Service Bulletin

Bulletin Number: **SB 22-0013-MH-1MBTU**

Subject: Maxi Heat circulation cap switch upgrade

Product Line: Maxi Heat 1MBTU

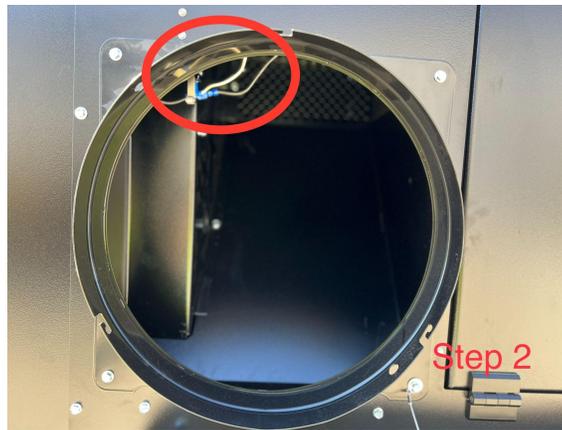
Step 1: Opening the air caps will verify if the unit was built with switches.

Step 2: Once the caps are removed, check the upper left corner of the inlet to verify if switches were installed.

Step 3: Kit 124434 is needed if your unit does not have switches installed. Each kit will include installation instructions, schematics and all the parts needed for the update. Please contact the Allmand parts department at 800-562-1373 or email the parts team at Allmand.parts@basco.com to purchase the retro kits
